# NOTICE OF PROJECT CHANGE

October 6, 2015

# Notice of Project Change

# Garden Garage

NORTH-SOUTH NEIGHBORHOOD SECTION LOOKING EAST

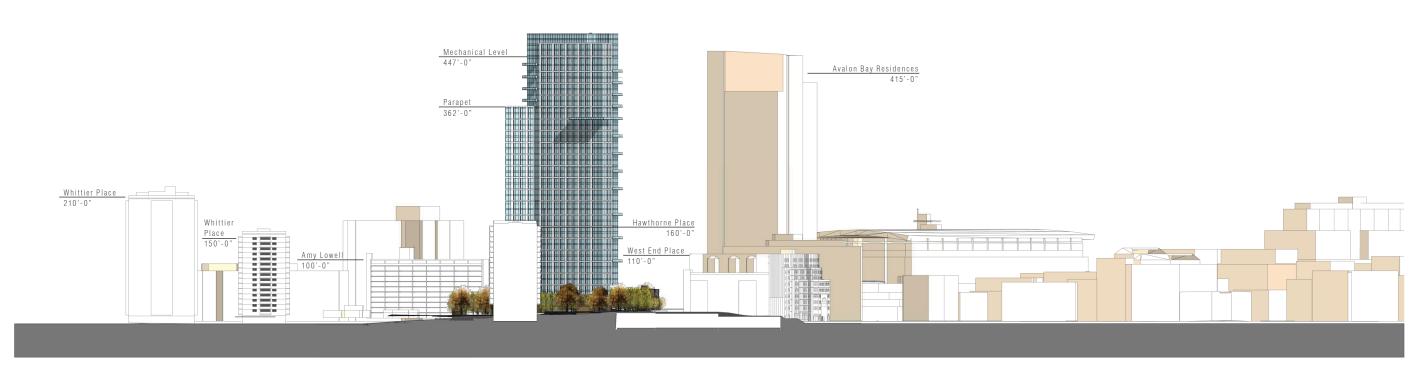
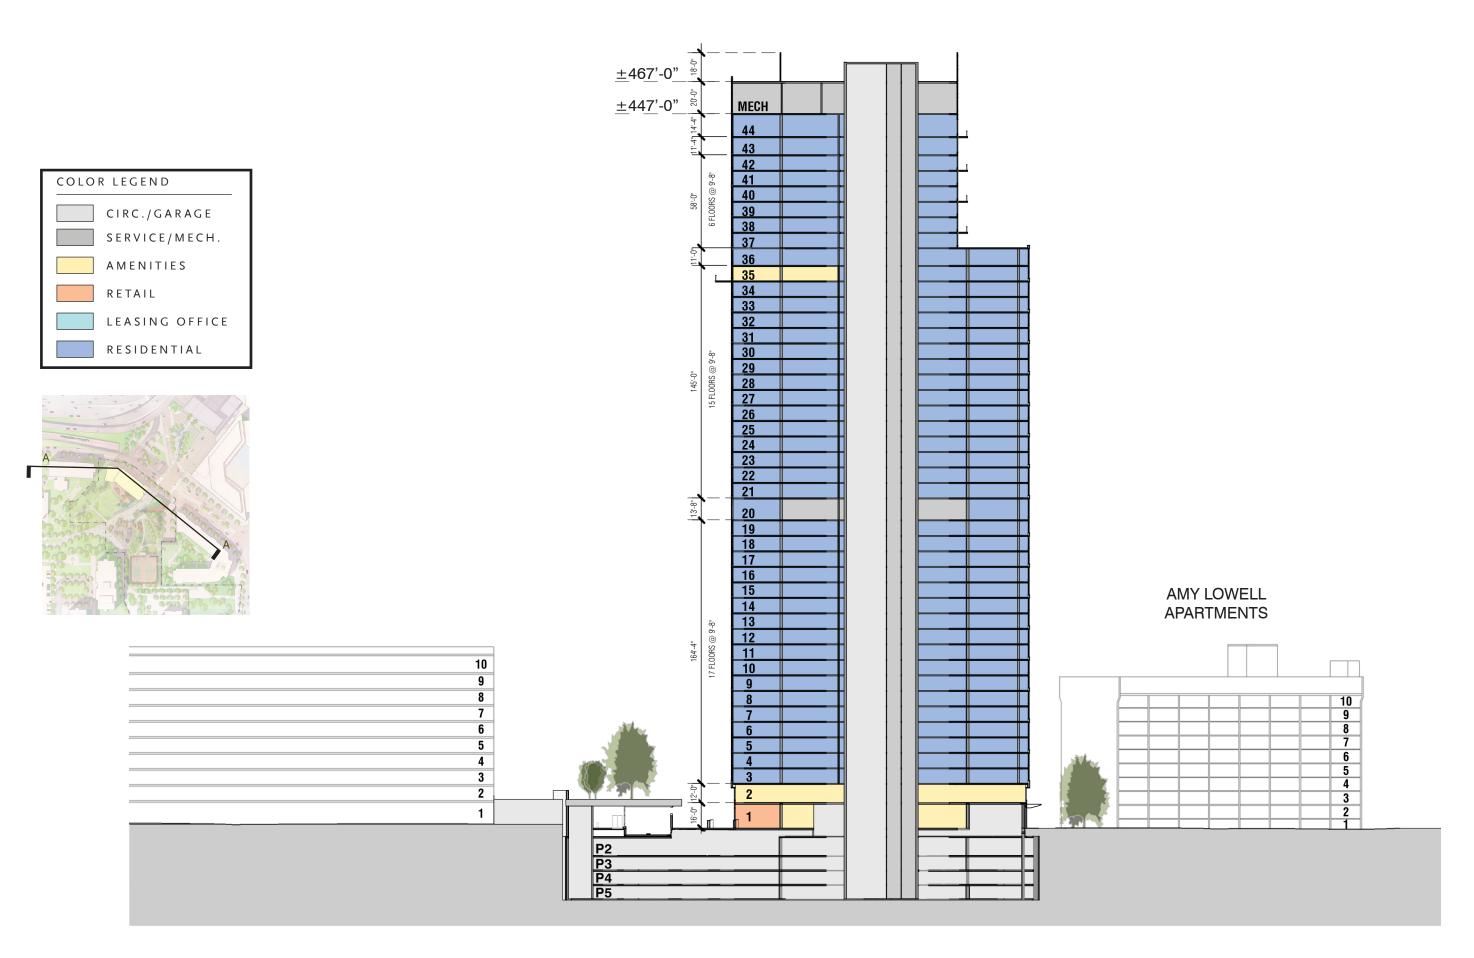
- Reducing the height from 46 stories/approximately 465 feet to 44 stories/approximately 447 feet (see Figures 2 to 4 for sections and elevations of the building in the area context);
- Creating fewer residential units, from approximately 486 units to approximately 470 units;
- Revising the unit mix to include ten three-bedroom units;
- Revising the footprint size resulting in an increased footprint of approximately 1,000 sf on the southeast side to minimize impacts on the Amy Lowell Apartments;

NORTH ELEVATION

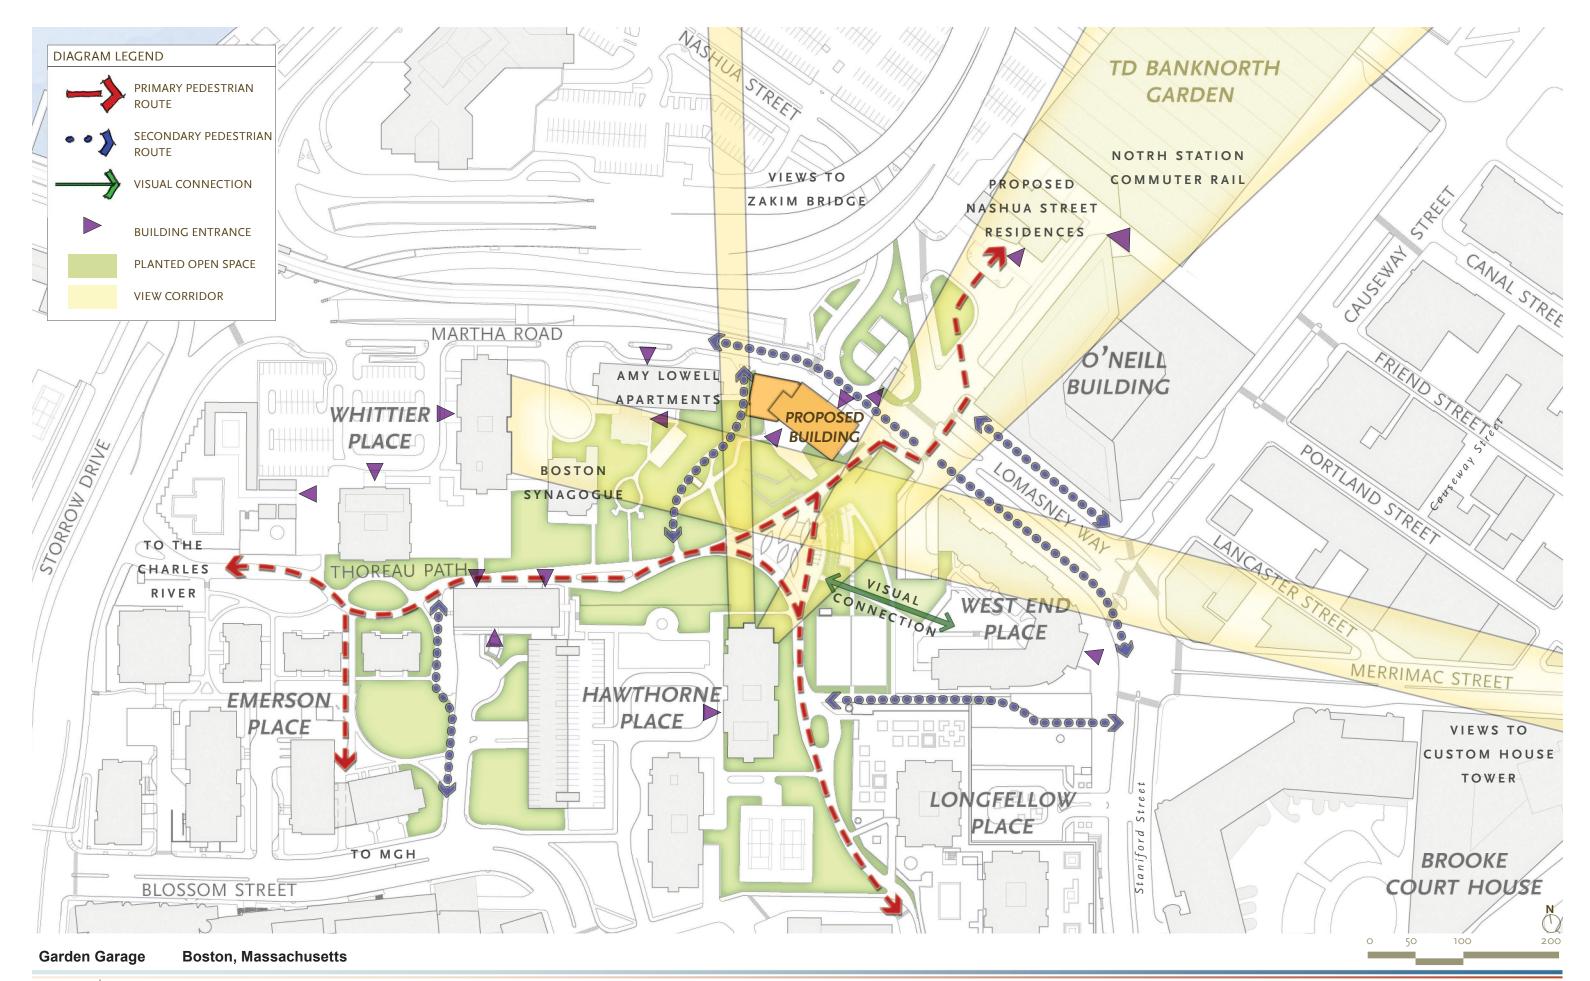
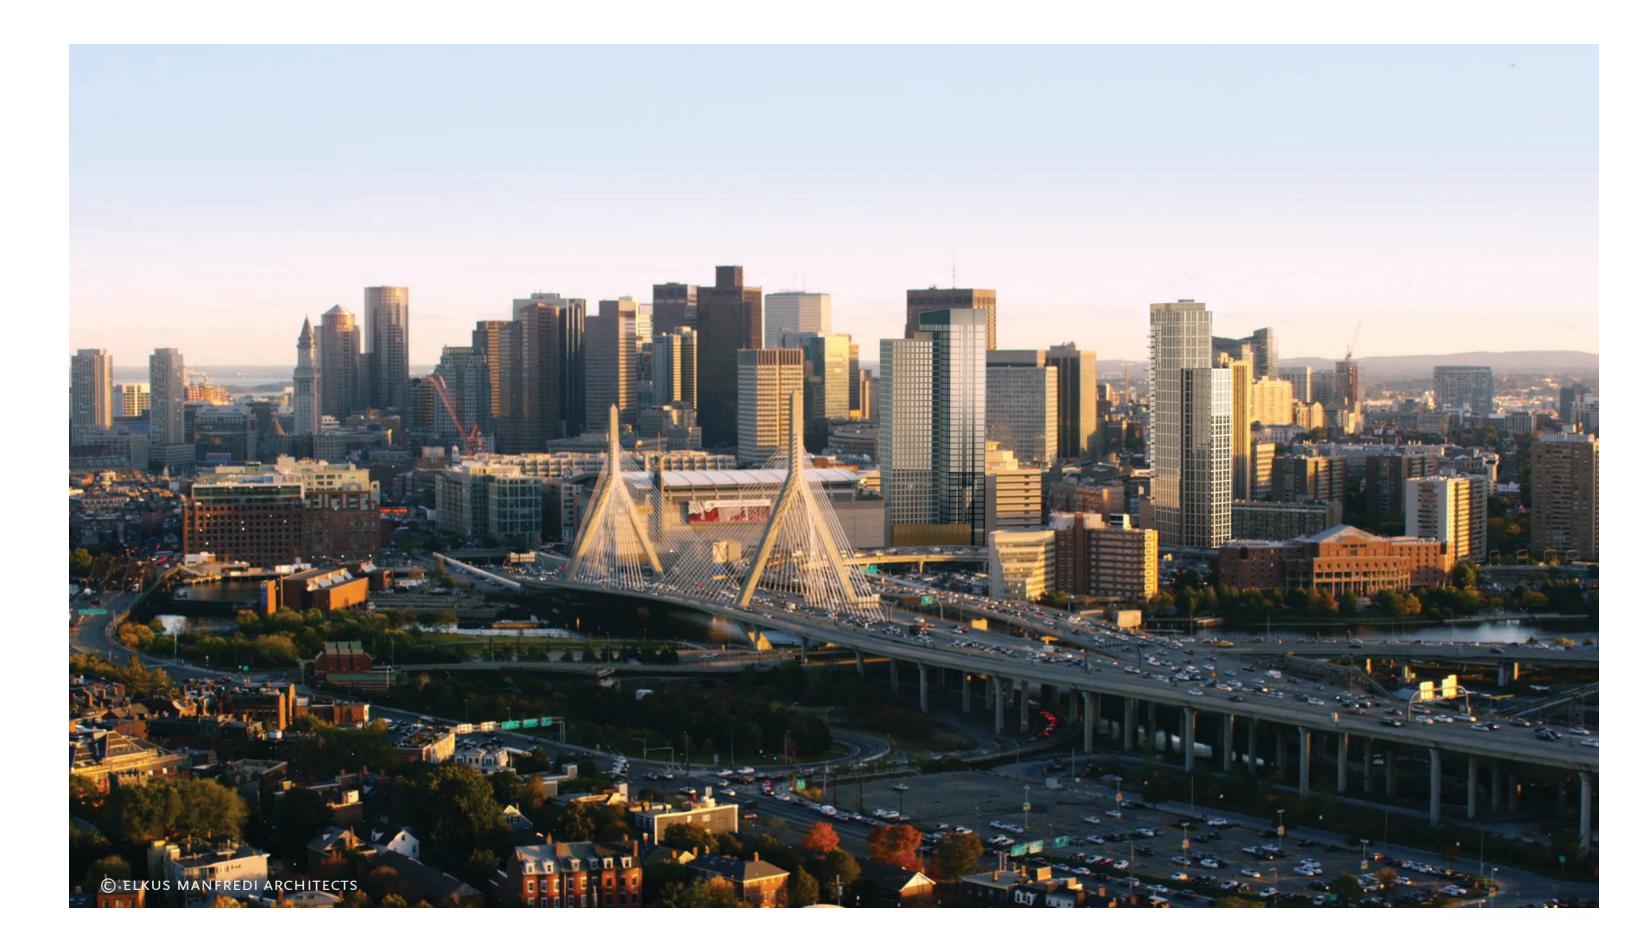
- Revising the exterior cladding material to include a glass and metal façade (see Figures 15 to 21 for elevations of the building and perspectives of the building).

PROPOSED SITE DEVELOPMENT

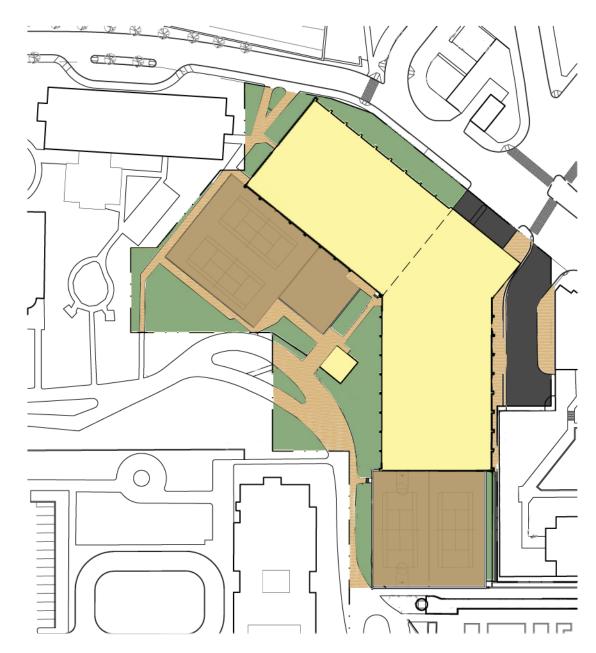
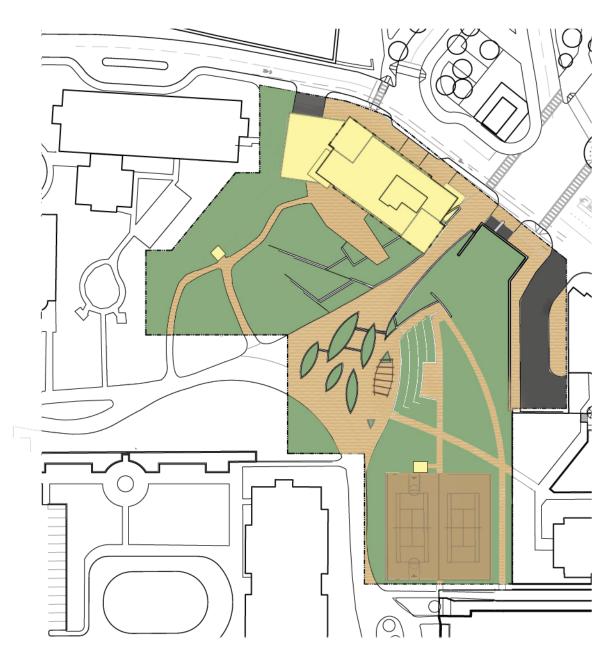
- Adjusting the footprint to the west to provide a wider sidewalk along Lomasney Way (see Figure 1);
- Redesigning the parking garage entry and exit lanes to provide additional queuing capacity on typical days and event days (see Figures 5 to 8 for existing and proposed queuing conditions);

THE STRATEGY OF PLACING THE PARKING BELOW GRADE SIGNIFICANTLY REDUCES THE OVERALL BUILDING FOOTPRINT ON THE SITE AND PROVIDES 38,742 SQUARE FEET (0.89 ACRES) OF NEW USEABLE OPEN SPACE ON THE SITE, A REDUCTION OF 2,506 SQUARE FEET (0.06 ACRES) OF OPEN SPACE FROM THE PREVIOUS NOTICE OF PROJECT CHANGE SUBMITTAL.
